# Access Compliance Report

## Public Rights-of-Way

### (Curb Ramps)

Intersection ID: 18436	Main Street: E_INDEPENDENCE_BV	Cross Street: SHARON_FOREST_DR	Location: SW
ADA ID: 4BD1BFCDD2FE	Ramp Type: PerpDiag	Initial Pass/Fail: Fail	Overall Compliance: No
		Severity Score: 35

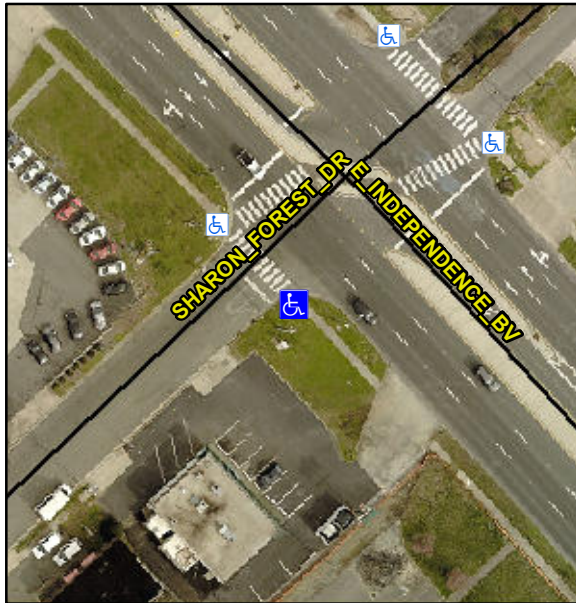
**Not Found, R304.5.1**

Compliance	Description	Data	Compliance	Description	Data
N/A	Ramp Length (in)	122.0	Yes	Ramp Slope (%)	7.9
No	Ramp Width (in)	29.0	Yes	Ramp XSlope (%)	0.6
N/A	Flare Type LT	N/A	N/A	Flare Type RT	N/A
N/A	Flare Slope LT (%)	N/A	N/A	Flare Slope RT (%)	N/A
N/A	Flare Traversable LT?	N/A	N/A	Flare Traversable RT?	N/A
N/A	Landing Length (in)	N/A	N/A	DWS Provided?	N/A
N/A	Landing Width (in)	N/A	N/A	DWS Contrast?	N/A
N/A	Landing Slope (%)	N/A	N/A	DWS Length (in)	N/A
N/A	Landing X Slope (%)	N/A	N/A	DWS Full Width?	N/A
N/A	Landing Curb? (Y/N)	N/A	N/A	DWS Offset (in)	N/A
N/A	Shared Landing?	N/A			
N/A	Gutter Ponding?	N/A	N/A	Gutter Slope (%)	N/A
N/A	Gutter Lip Ht (in)	N/A	N/A	Gutter X Slope (%)	N/A
N/A	Painted X Walk1?	No	N/A	Painted X Walk2?	Yes
	X Walk 1 Direction	To NE		X Walk 2 Direction	To NW
N/A	X Walk 1 Width (in)	N/A	N/A	X Walk 2 Width (in)	116.0
	X Walk 1 Slope (%)	2.5		X Walk 2 Slope (%)	3.3
	X Walk 1 X Slope (%)	1.8		X Walk 2 X Slope (%)	2.1

**Remove & Replace Curb Ramp With Two New Directional Ramps or Equivalent.**
